**CITY OF MERIDIAN
FINDINGS OF FACT, CONCLUSIONS OF LAW
AND DECISION & ORDER**

Case No(s). H-2023-0031

STAFF REPORT

SUBJECT: Windrow Neighborhood
[H-2023-0031](#)

D. Revised Open Space Exhibit:

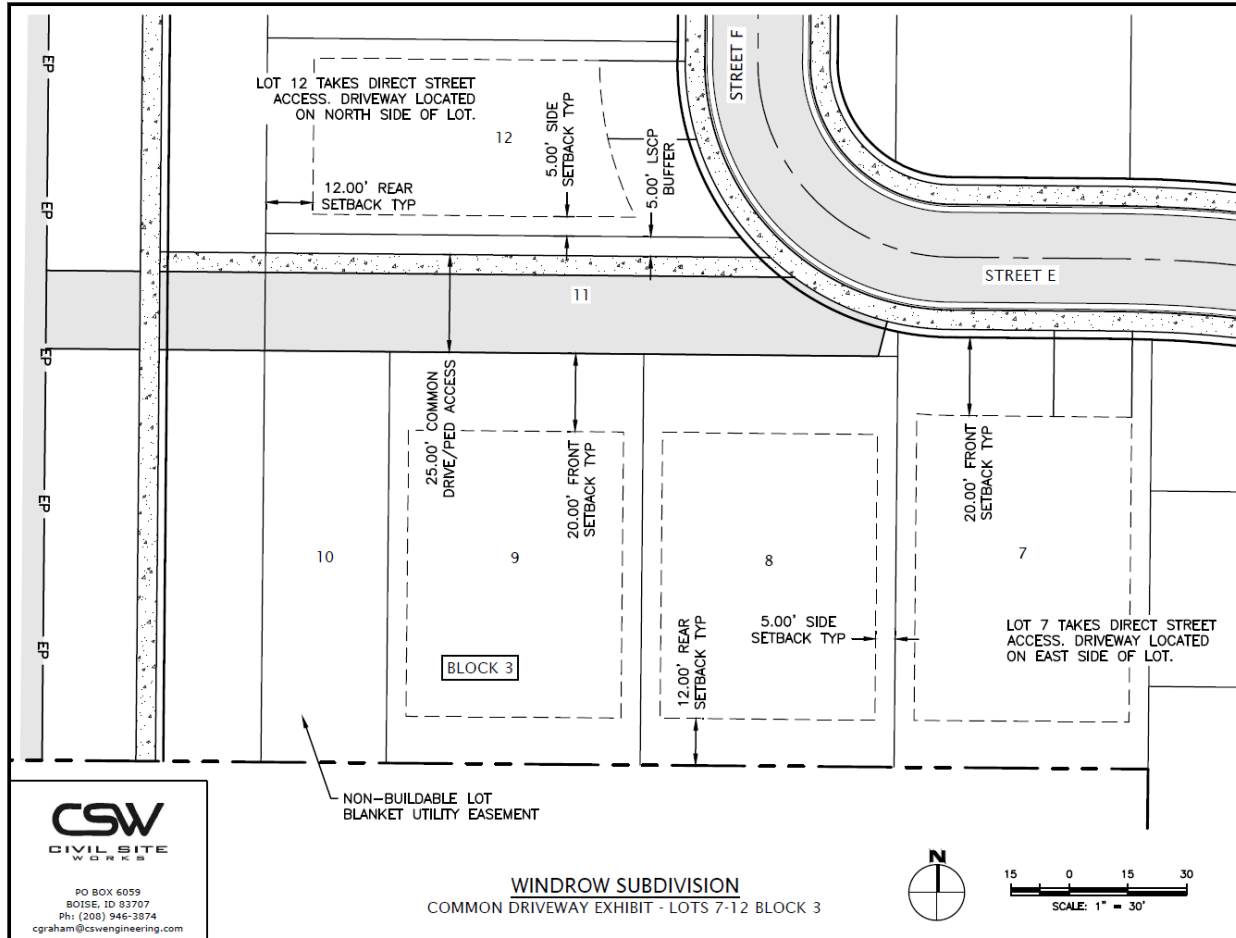
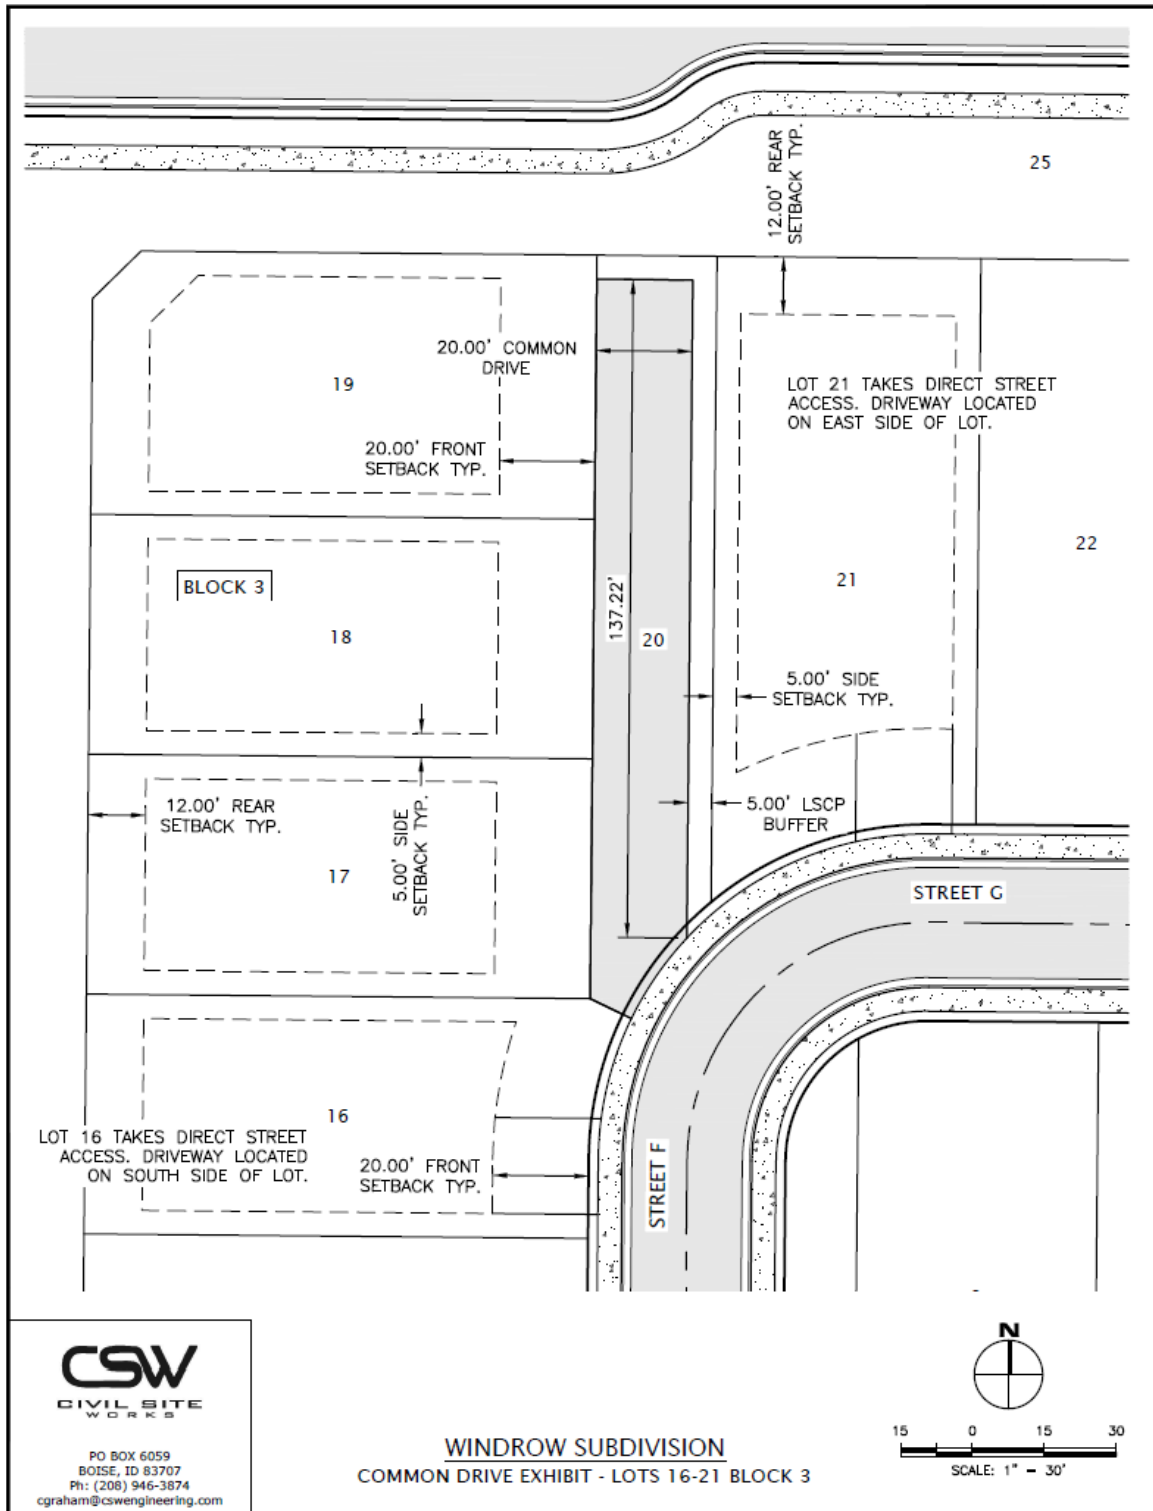
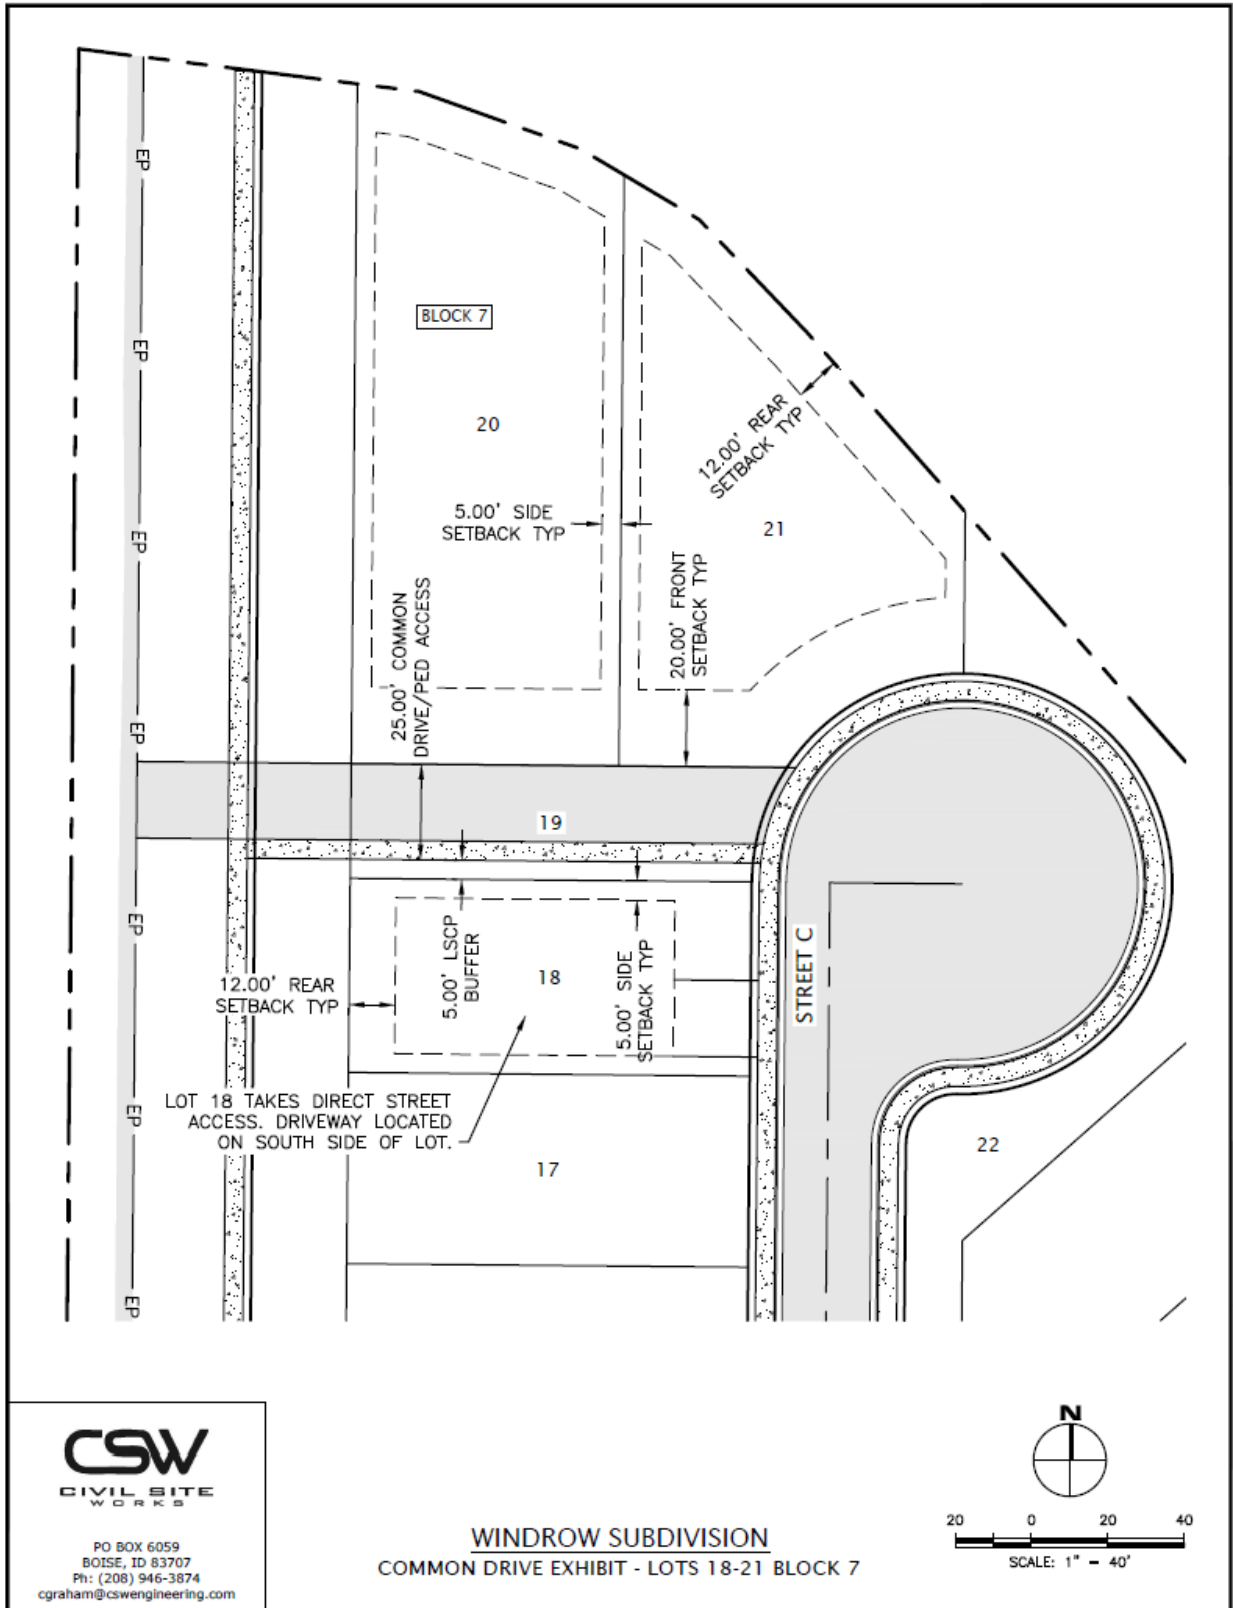
areas automatically qualified towards the minimum open space but this is no longer the case with the latest open space code updates that desires for more than the minimum to be included within the required buffers in order to count towards the overall qualified open space for a project. The Applicant appears to comply with all four (4) points outlined in code (See Section VIII. D & E). Additionally, the parkways depicted on the Open Space Exhibit as qualifying open space appears to meet the three (3) points outlined in code (See Section VIII. D & E).
